Nuclear Innovation
North America LLC
4000 Avenue F, Suite A
Bay City, Texas 77414

August 28, 2012
U7-C-NINA-NRC-120057

South Texas Project
Units 3 and 4
Docket Nos. 52-012 and 52-013
Supplemental Response to Request for Additional Information

RAI 03.08.04-18, Supplement 4**QUESTION:****Follow-up to Question 03.08.04-2 (RAI 2964)**

Figure 3H.6-48: Resisting Lateral Pressure on the East, West, and North Walls of Pump House (for Stability Evaluation)

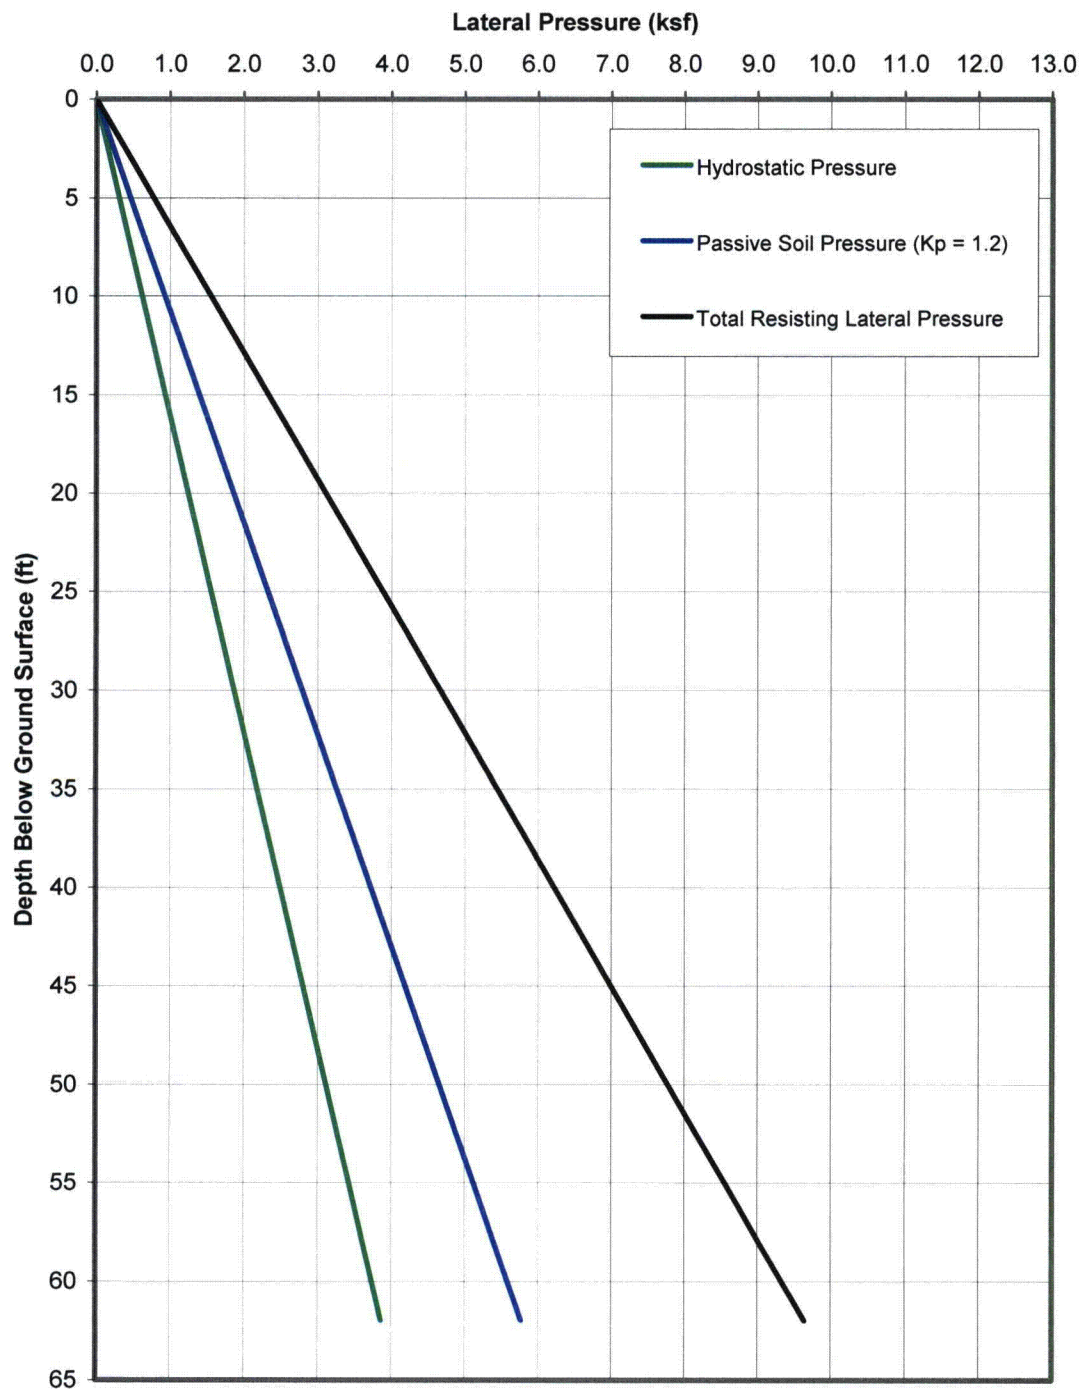
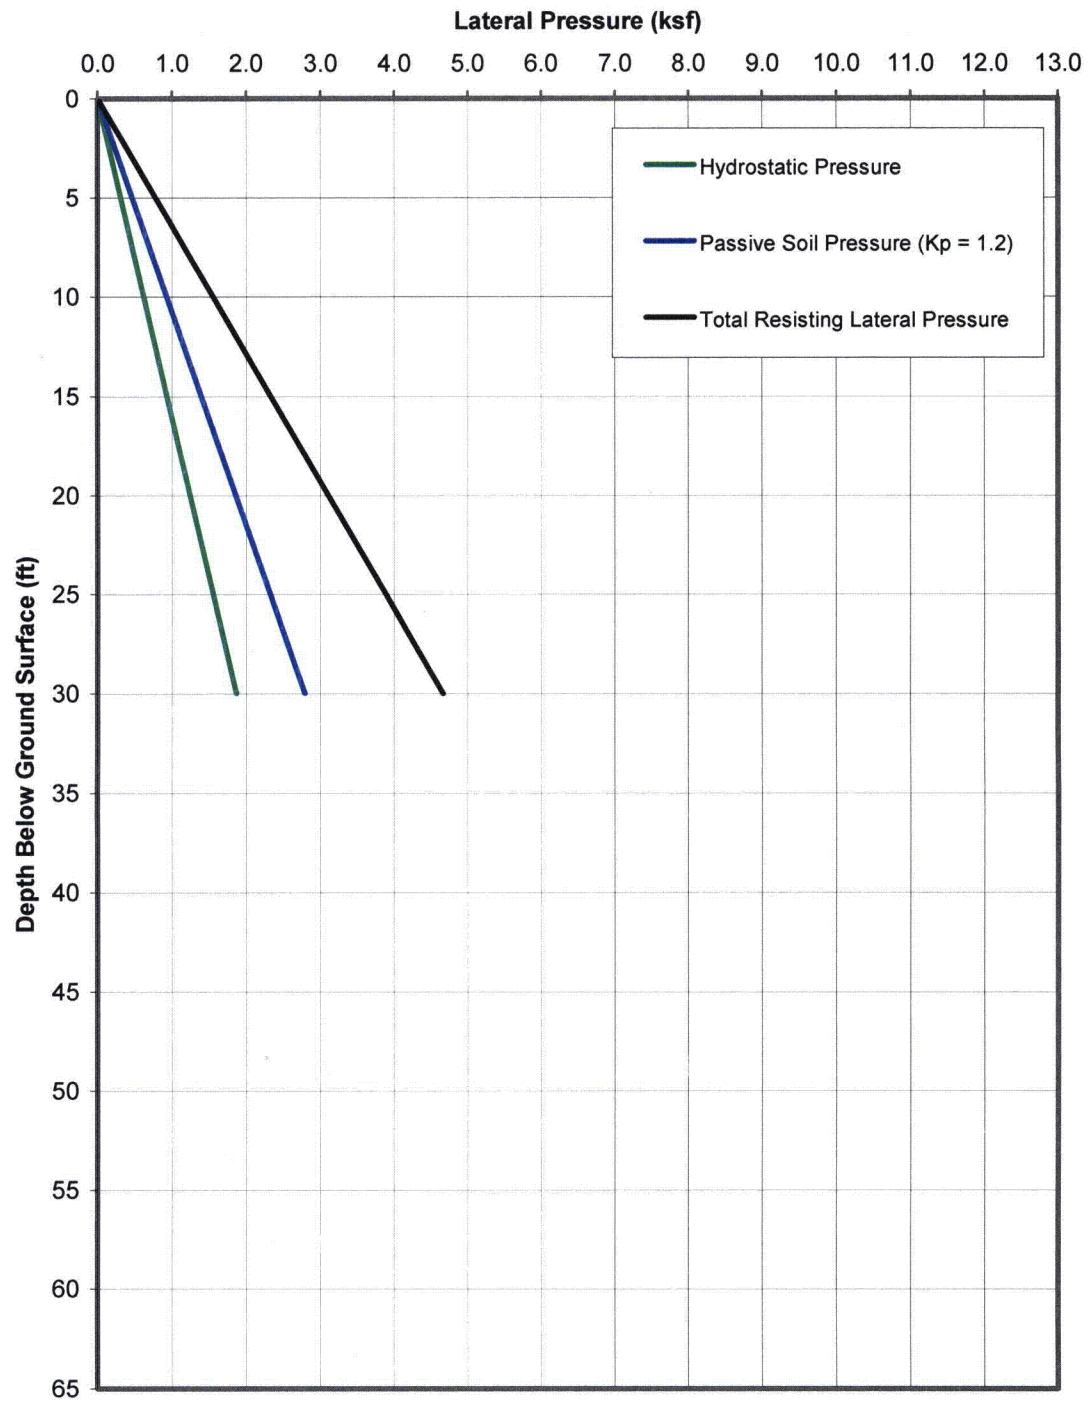
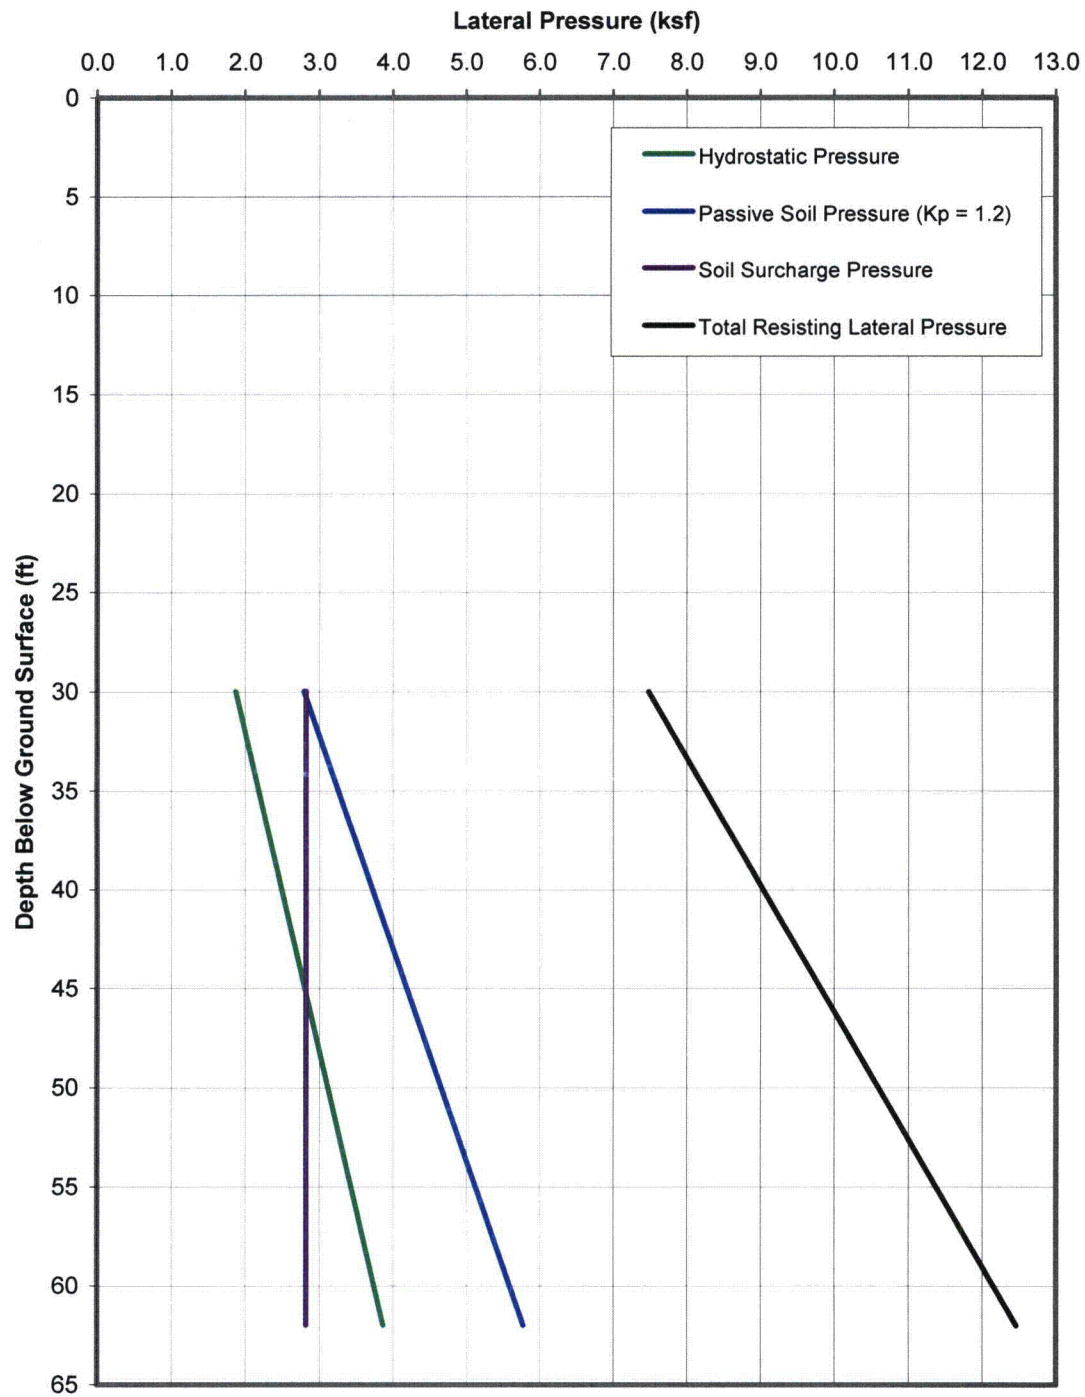
7. *Revise COLA Figures 3H.6-48 through 50 to show passive soil pressures needed for stability (**Punch List Item 267**)*

See Enclosure for COLA markup of Figures 3H.6-48 through 3H.6-50.

$P_{\text{at-rest}}$ = Total at-rest soil pressure (see Figures 3H.6-48 through 3H.6-50)

Figure 3H.6-137: Formulations Used for Calculation of Factors of Safety Against Sliding and Overturning for Category I Site-Specific Structures

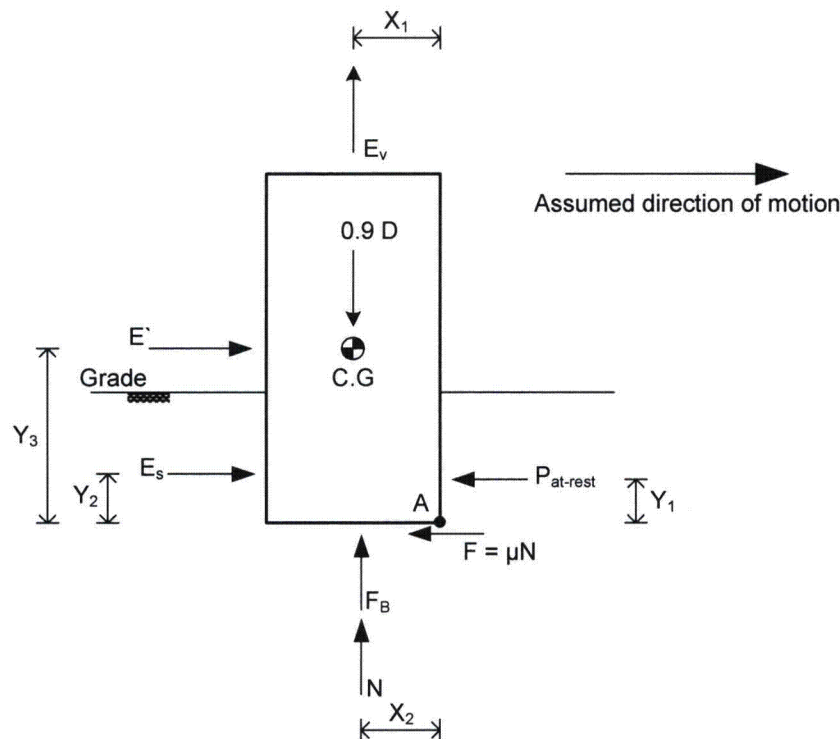
5. *Provide additional explanation for simultaneous consideration of sliding and overturning about two horizontal axes in COLA (Punch List Item 265)*

6. *Revise COLA Figure 3H.6-137 to remove reference to UHS figures (**Punch List Item 266**)*

See Enclosure for COLA markup of Figure 3H.6-137.

Note: Figure 3H.6-137 presents the formulations for sliding and overturning check for a single horizontal direction earthquake. When considering two horizontal (X and Y) excitations, the formulations of Figure 3H.6-137 remain unchanged except that the friction force (F) along the X or Y direction is replaced with F_x and F_y (friction force along the x and y axes, respectively). F_x and F_y forces are determined as follows:

Figure 3H.6-40: SAP Finite Element Model for UHS and RSW Pump House Design

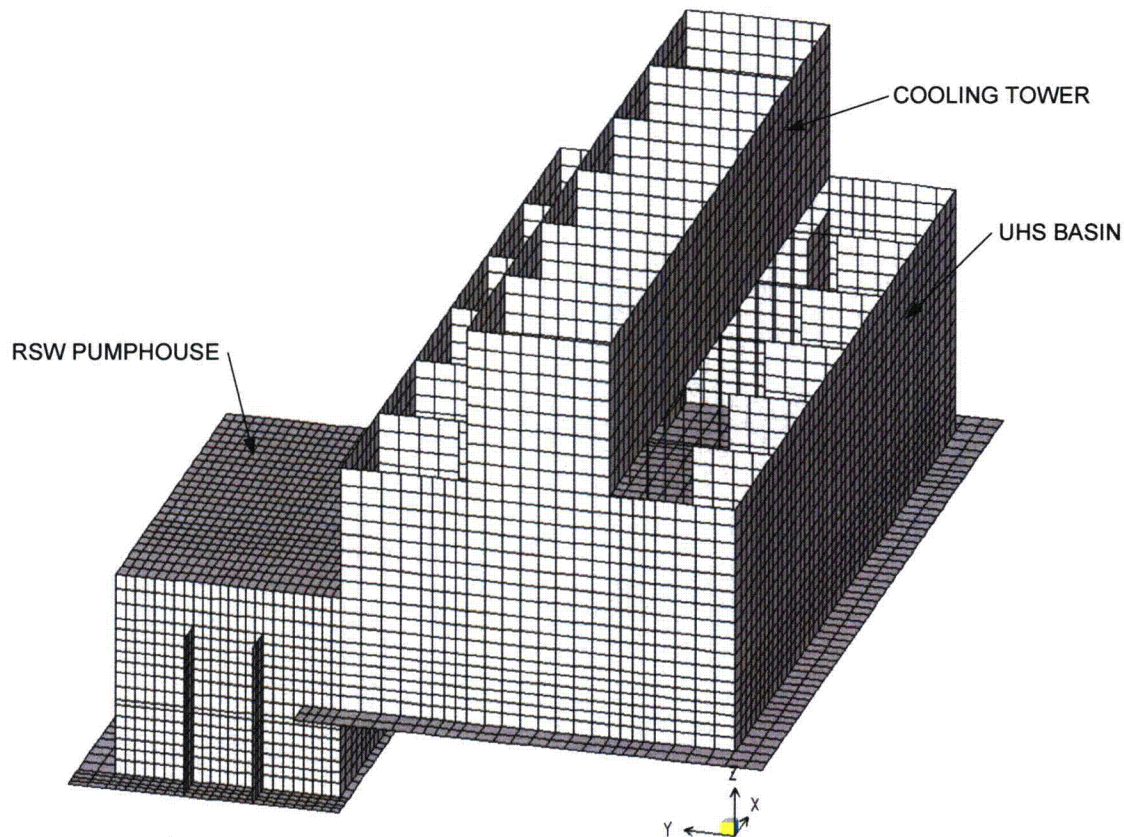
In its response to Question 03.08.04-13, the applicant referred to FSAR mark-up provided in response to question 03.07.01-13 for structural analysis and design information for site-specific seismic category I structures (Letter U7-C-STP-NRC-090112 dated August 20, 2009). The staff noted that the above referenced response did not include all tables and figures referenced in the FSAR mark-up, and these are stated to be provided later. In addition, the level of detail included in FSAR Section 3H.6.6.3 regarding structural design of the various elements of site-specific structures is not sufficiently descriptive, and is not similar to that included in the ABWR DCD. Therefore, the applicant is requested to include in FSAR Section 3H.6.6.3 description of the various steel and concrete elements of the site specific structures including how these elements are designed including design results.

The original response to this RAI was submitted with STPNOC letter U7-C-STP-NRC-100036, dated February 10, 2010. This revision is being provided in response to Punch List Item 268 to explain why lower bound soil spring values were selected for use in the Finite Element Analysis (FEA) of Ultimate Heat Sink (UHS)/Reactor Service Water (RSW) pump house. The revisions are indicated by revision bars in the margin.

Since use of softer soil springs will result in higher basemat forces, lower bound soil springs were selected for use in the Finite Element Analysis of the UHS/RSW Pump House.
